VIRM: IN-SERVICE CERTIFICATION AMENDMENT

December 2019 List of changes and preview pages (WoF only)

IN THIS AMENDMENT

Information on LVV plate differs from the vehicle

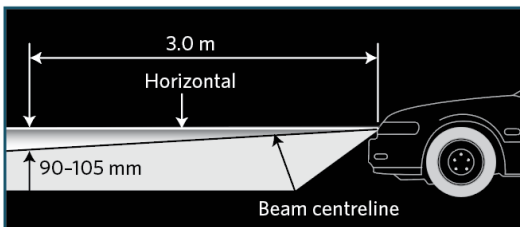
Where the information on the LVV plate (other than the vehicle's registration plate or due to the temporary removal of seats) differs from the vehicle, for example where a vehicle has been further modified or returned to original, the vehicle must be failed and sent to an appropriate LVV certifier:

Symmetric dipped beam

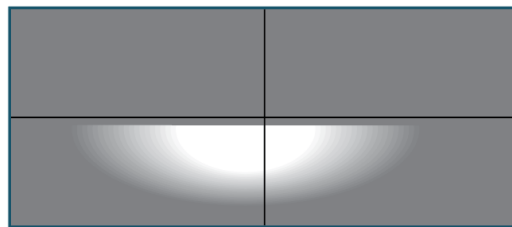
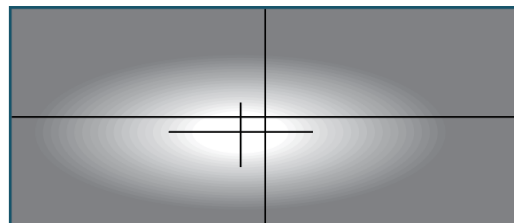
SECTION	CHANGE DESCRIPTION
Introduction	
3-1 Duties and responsibilities	<ul style="list-style-type: none"> • Adds a further exception to where it is ok if the information on an LVV plate differs from the vehicle – in this case temporary removal of seats (see also the change to note 6 in 7-1 below)
General vehicles	
All relevant lighting sections	<ul style="list-style-type: none"> • To remove doubt for WoF and CoF inspection purposes, lamp overlays that reduce or distort emitted light are a fail item.
4-1 Headlamps	<ul style="list-style-type: none"> • Modern dipped beam headlamps have a different pattern than older style lamps. Figure 4-1-2 has been updated to include both older and modern style dipped beam headlamp patterns that are acceptable.
5-1 Glazing	<ul style="list-style-type: none"> • Plain English rewrite of the fitting and modifications requirements for windows in class ME vehicles (heavy buses)

Modern symmetric dipped beam headlamp pattern on light board

Older-style symmetric dipped beam headlamp pattern on light board
